EXHIBIT "J"

December 2, 2010

**Patrick Farm Subdivision, Condominiums and Volunteer Housing  
Talking Points for Planning Board Public Hearing  
Town of Ramapo, New York  
November 29, 2010**

*Draft Environmental Impact Statement Figure 3.9-14  
Key Map of Architect's Renderings for Patrick Farm*

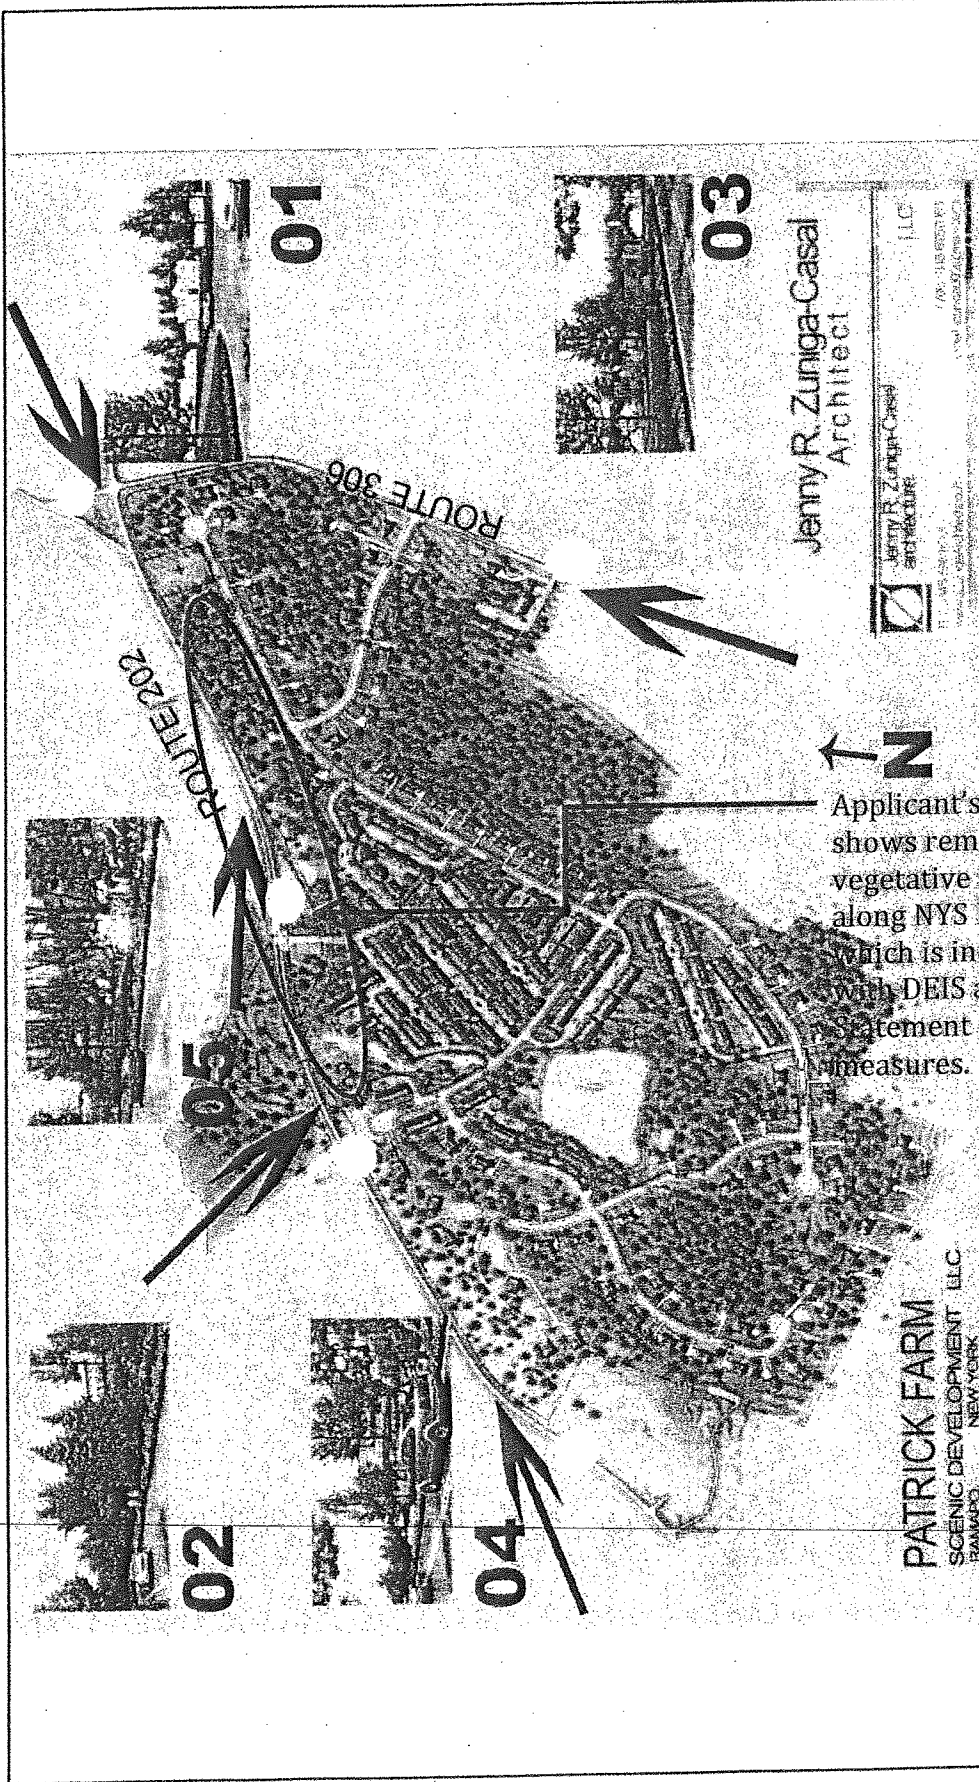
- DEIS Figure 3.9-14: Key Map of Architect's Renderings for Patrick Farm clearly shows preservation of existing vegetation between Old Haverstraw Road and NYS Route 202 without retention basins. The proposed Sketch Plan for the Subdivision shows the existing trees in this vicinity removed, thereby eliminating an important mitigation measure (i.e. undisturbed vegetative areas around the perimeter of the site).
